## **RESPONSE TO SUBMISSIONS: PROPOSED MANUFACTURING FACILITY AND ASSOCIATED WAREHOUSE**

657-769 MAMRE ROAD, KEMPS CREEK  
LOT 10 APPROVED UNDER SSD 9522

**7 September 2022**

TABLE 1: RESPONSE TO AGENCY SUBMISSIONS			
SUBMITTER	MATTERS RAISED	COMMENTS / REQUESTS	FORMAL RESPONSE
			<div> <div>Entry</div> </div> <p><b>Figure 1      Truck Entry Swept Path</b> (Source: Ason Group, 2022)</p>

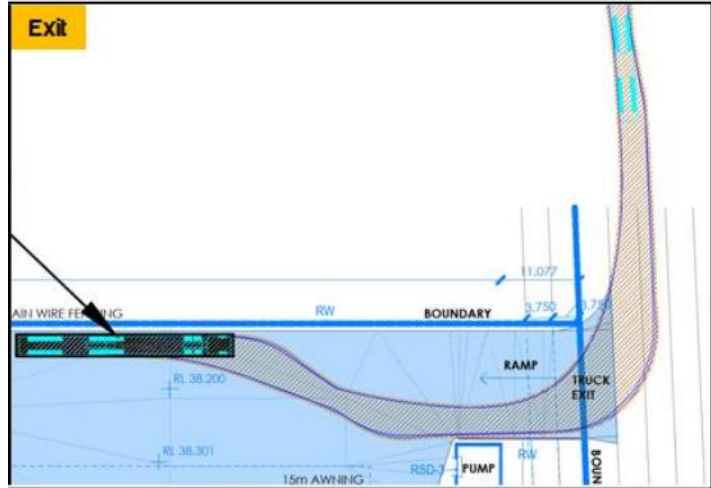
SUBMITTER	MATTERS RAISED	COMMENTS / REQUESTS	FORMAL RESPONSE
		The Department is to be satisfied that the applicant's Environmentally Sustainable Design (ESD) report provides details as to the measures which will be implemented as a result of the development and what outcomes will be achieved by such measures.	
	Development Engineering Considerations	<p><b>a. Development Engineering Traffic Matters</b></p> <p>The widths of the vehicle driveways, crossovers and laybacks for heavy vehicles within the public verge areas as shown on the architectural plans, differ to the engineering plans.</p> <p>Turn path diagrams provided in the Transport Assessment report by Ason Group dated 05.11.2021 show a Super B-Double Quad-Quad heavy vehicle entering and exiting the site by encroaching over the frontage of the adjoining lot within the verge area, which is not supported.</p>	<p>The external roads are designed for the 30m Super B-double as per SSD 9522 (Condition A6). Further the design has been tested for the 36.5m PBS Level 3 &amp; 4 vehicle as required of the MRP DCP.</p> <p>It is emphasised that the largest size truck is expected to be a 26.0m B-Double truck based on the tenant's advice, however, the assessment has been based on a 30.0m Super B-Double truck which is deemed conservative.</p> <p>Furthermore, the 30.0m Super B-double truck does not enter and exit the Site by encroaching over the frontage of the adjoining lot. Rather, the vehicle enters and exits over the proposed vehicular crossovers that have been shown on the plans, as shown in <b>Figures 1 and 2</b> below.</p>

**Figure 7**      **Operation Process Flow** (Source: Ardex, 2021)

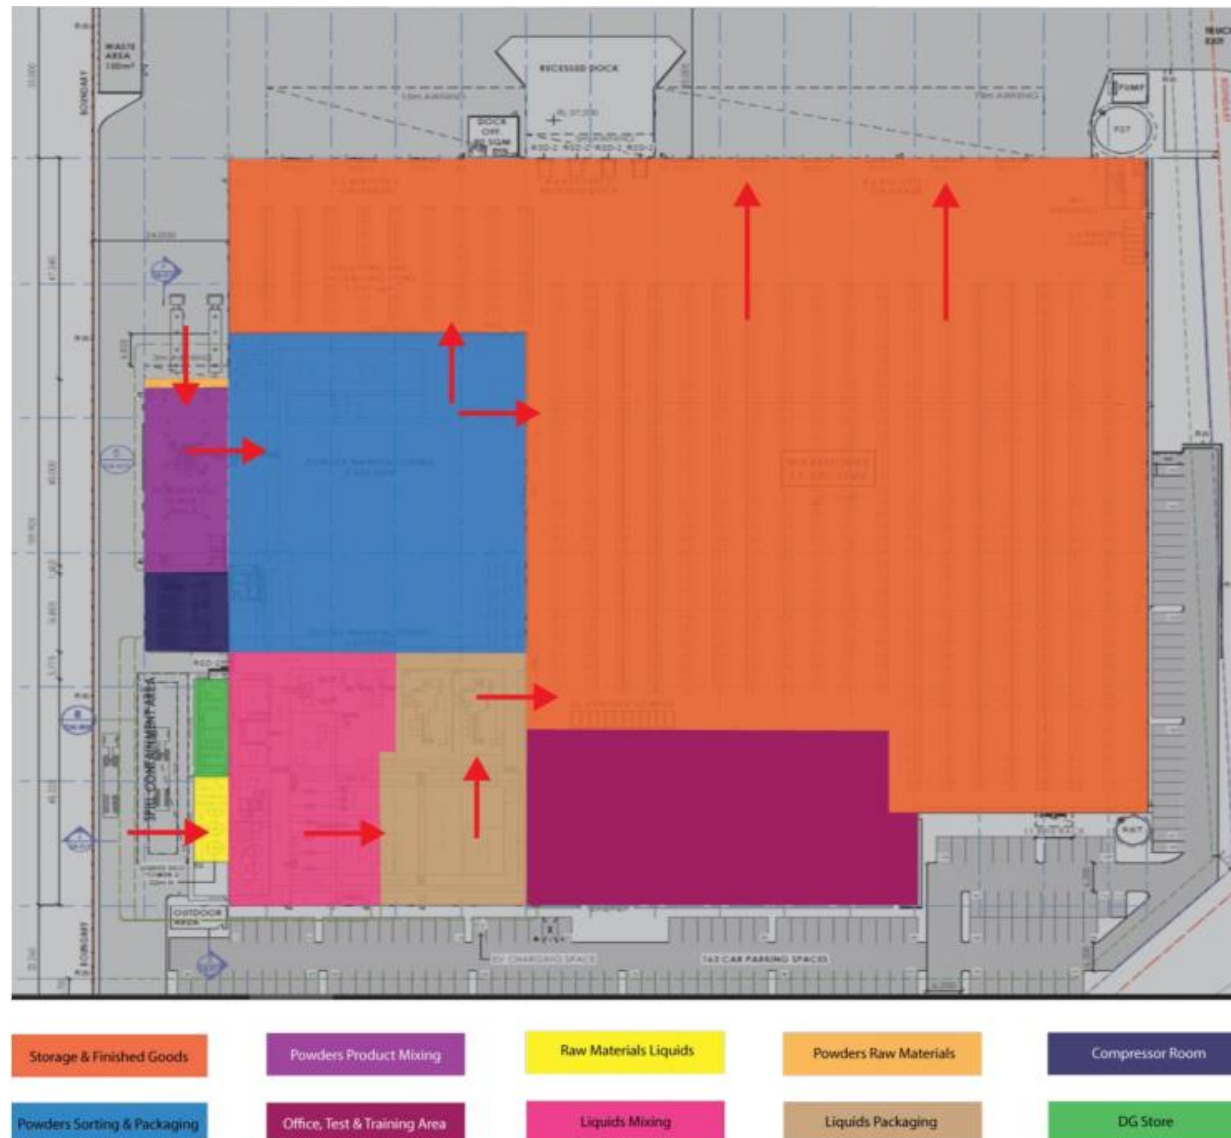
The Department notes Figure 16 in the EIS is not legible. The RtS must include updated and legible figure.	An updated Figure 16 has been reproduced below as <b>Figure 7</b> of this RTS
		The EIS and Civil Report propose indicative finished site levels of +/- 500 mm. Where finished site levels and building heights are unknown, the worst-case scenario should be assessed. The RtS and relevant technical assessments including but not limited to the Architectural Plans, Visual Impact Assessment Report and Civil Report should be revised.	Updated development statistics have been provided within <b>Table 2</b> of this RTS and the relevant technical assessments have been updated to include the worst-case scenario having regard to building height.

Figure 8

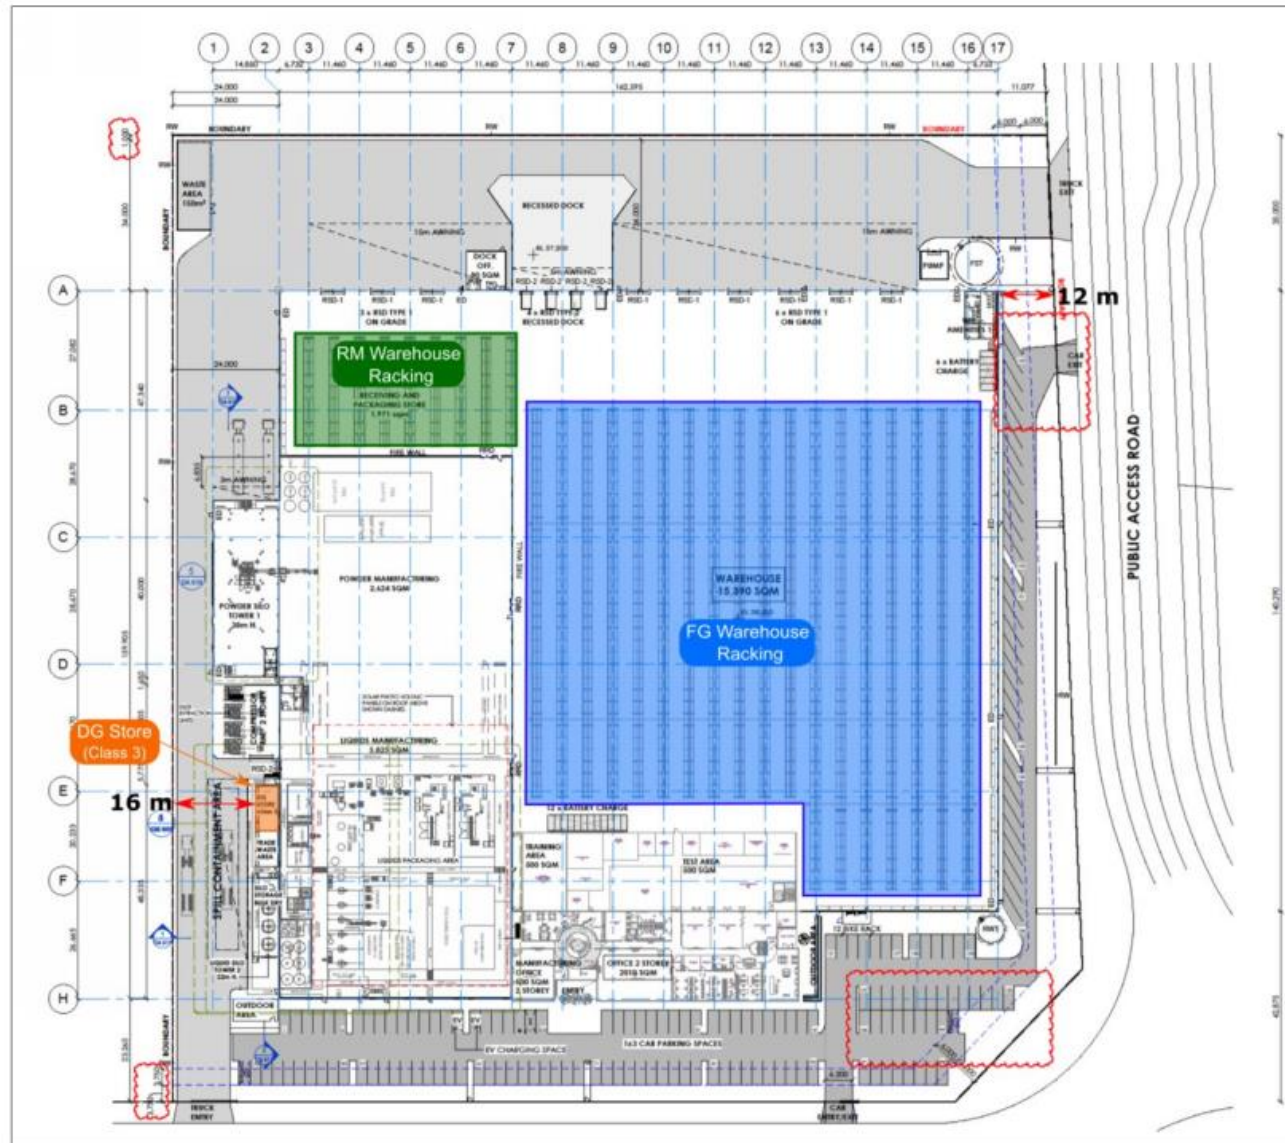
<b>NSW (Hazards)</b>	<b>DPIE</b>	<p>-</p> <p>The State Environmental Planning Policy No. 33 Report (SEPP 33 Report) presents the quantities of Dangerous Goods (DGs) in Table 3-1 and undertakes a preliminary risk screening in section 3.3. We make the following comments on the preliminary risk screening.</p> <p>a. The Department highlights that there were inconsistencies in separation distances used for preliminary risk screening of flammable liquids in the SEPP 33 Report. On page 6 of the SEPP 33 Report, describes 9 metres separation for risk screening of</p>	<p>The Dangerous Goods Report (<b>Appendix C4</b> of this RTS) has been corrected such that the assessment of flammable liquids has been conducted using a separation distance of 12m. Please note that in the review process, the quantity of</p>

SUBMITTER	MATTERS RAISED	COMMENTS / REQUESTS	FORMAL RESPONSE
		<p>flammables. In Figure 3-1 of the SEPP 33 Report, the smallest distance is 12 metres to site boundary and in Figure 3-4, 16 meters separation is applied for preliminary risk screening. As such the Department is unclear on validity of the preliminary risk screening of flammable liquids given the smallest separation from the warehouse to the site boundary is 12 metres;</p> <p>b. From Table 3-1 of the SEPP 33 Report the DG Class 8 are listed as two (2) packing groups. Packing Group II (13,302kg) and Packing Group III (21,297kg). As per "Applying SEPP33", page 16, where a DG class of differing packing groups are "kept on site in the same general location" then the most hazardous packing group is applied to total class storage. As such the DG Class 8 material should be totalised as Packing group II (34,599 kg) and would exceed the threshold quantities in "Applying SEPP 33"; and</p> <p>c. The Department seeks clarification on whether any of the Class 9 or other hazardous materials are defined as a combustible liquid C1 (as classified by AS 1940) and stored at the proposed development. We request the Applicant provide any quantity of combustible liquid C1 to be stored at the proposed development. As per "Applying SEPP33", page 16, where combustible liquids C1 are kept within a store with flammable liquids they are treated as DG Class 3 PGIII and must be added to the flammable liquids' quantity when undertaking the preliminary risk screening.</p> <p>Given the above, the Applicant has not demonstrated that the quantities of DGs to be stored at the proposed development are below the threshold screening quantities in "Applying SEPP 33". As such, the Applicant must undertake a preliminary risk</p>	<p>Class 3 DGs to be stored has been reduced. The original DG storage quantities were based on Ardex acquiring a business which required the storage of a range of DGs similar to the DGs stored, handled and processed by Ardex. This business venture is no longer being pursued and, hence, the quantities of DGs have been reduced to those listed in the updated SEPP 33 study.</p> <p>The Dangerous Goods Report (<b>Appendix C4</b> of this RTS) has been updated such that PG II and PG III Class 8 substances are assessed together. Note that in the review process, the DG quantities to be stored at the facility have been reduced, therefore the SEPP 33 thresholds are not exceeded.</p> <p>A review of the SDS of the Class 9 DGs indicates that no combustible liquids (C1) will be stored.</p> <p>As per the above, the proposed development will not exceed SEPP 33 thresholds and therefore, no preliminary risk</p>

SUBMITTER	MATTERS RAISED	COMMENTS / REQUESTS	FORMAL RESPONSE
		<p>screening in accordance with State Environmental Planning Policy No. 33 – Hazardous and Offensive Development and Applying SEPP 33 (DoP, 2011), given points (a) to (c) above. The Applicant, as per the SEARs, should provide a layout, clearly indicating the location of the dangerous goods to be stored for the proposed development.</p> <p>Should the risk screening indicate that the proposed development is “potentially hazardous” a Preliminary Hazard Analysis (PHA) must be prepared in accordance with Hazardous Industry Planning Advisory Paper No. 6 – Guidelines for Hazard Analysis (DoP, 2011) and Multi-Level Risk Assessment (DoP, 2011).</p>	<p>screening or further assessment is required to be undertaken.</p>
		<p>The proposed development will incorporate an office space. The Department highlights that these offices would be classified as an on-site protected place by Australian Standards for the handling of DGs. The Department seeks information on separation of the warehousing areas (containing DGs) to the offices, noting the requirements of Australian Standards for storage and handling DGs.</p> <p>Furthermore, in section 3.2.12 of the EIS, future batching and packaging of flammable liquids is described. As such, the Department seeks information regarding the application of AS 1940 Appendix L regarding separation of the liquid processing area to the offices (on-site protected place) and other areas.</p>	<p>DGs will be stored in the Class 3 Store, in the Raw Materials (RM) warehouse and in the Finished Goods (FG) warehouse. The required separation distances are as follows:</p> <ul style="list-style-type: none"> <li><u>Class 3 DG Store</u>: 10m separation is required as per Table 4.1 of AS 1940-2017.</li> <li><u>FG/RM Warehouse</u>: As only manufactured products in retail-size packages are stored in this area, it has been classified as a retail distribution centre (RDC) under AS/NZS 3833:2008. RDCs do not have specified separation distances to protected places. However, as per Clause 3.2.5(e) of the standard, the walls of the warehouse adjacent to offices shall be constructed of fire walls with an FRL of 60/60/60.</li> </ul> <p>As shown in <b>Figure 8</b> below, these separation distances have been met.</p>
